ADDENDUM NUMBER 2

Date: January 20, 2023
Project: **Bayou Terrebonne Debris Removal Project No. 22-NRCS-43**
From: All South Consulting Engineers, LLC
652 Papworth Avenue
Metairie, LA 70005
(504) 322-2783
To: All Bidders

This Addendum No. 2 forms a part of the Contract Documents and modifies the original Bidding Documents dated November 16, 2022 as noted below. Acknowledge receipt of this Addendum in the space provided on the Bid Form. Failure to do so will subject the Bidder to disqualification. Bidder is responsible to disseminate this Addendum to all subcontractors and material suppliers concerned.

SEGMENTS 53-55
SCALE: 1" = 100'

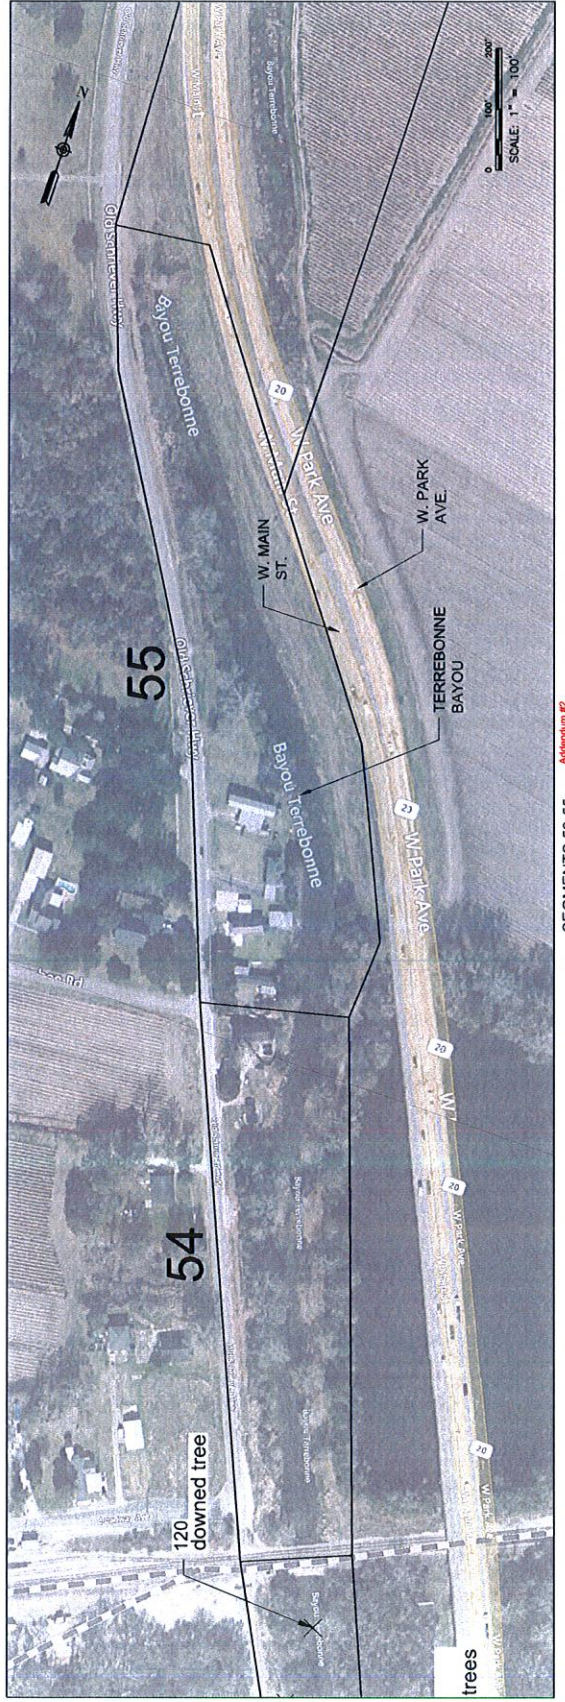
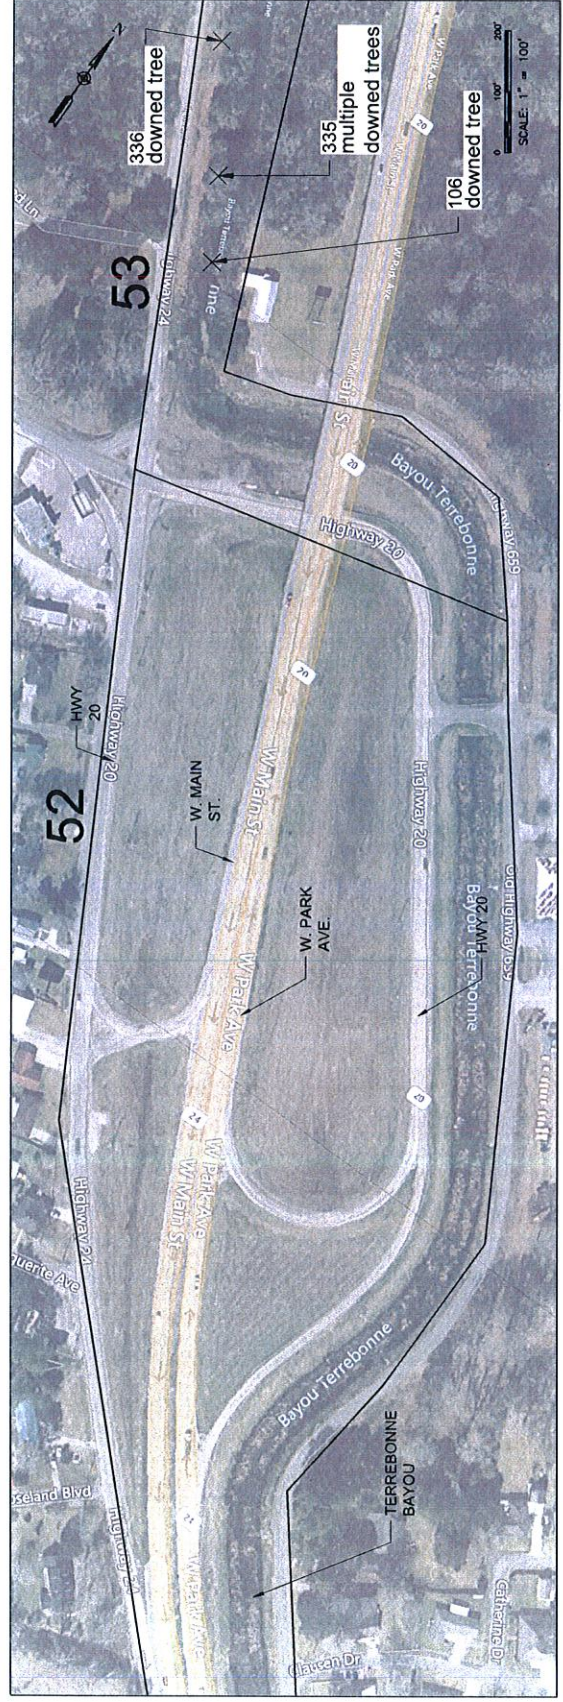
Question 18: The “New” Project Drawings show Targets or Debris Points for each Numbered Segments. The Bid Form has Segment 54. However, Drawing 14 does not show a Target or Debris Point for Segment 54. Is there any Debris Removal for Segment 54? If there is not Debris to be removed in Segment 54, will a new Bid Form be issued? Please advise.

Answer 18: Segment 54 scope includes branches along the bank line.
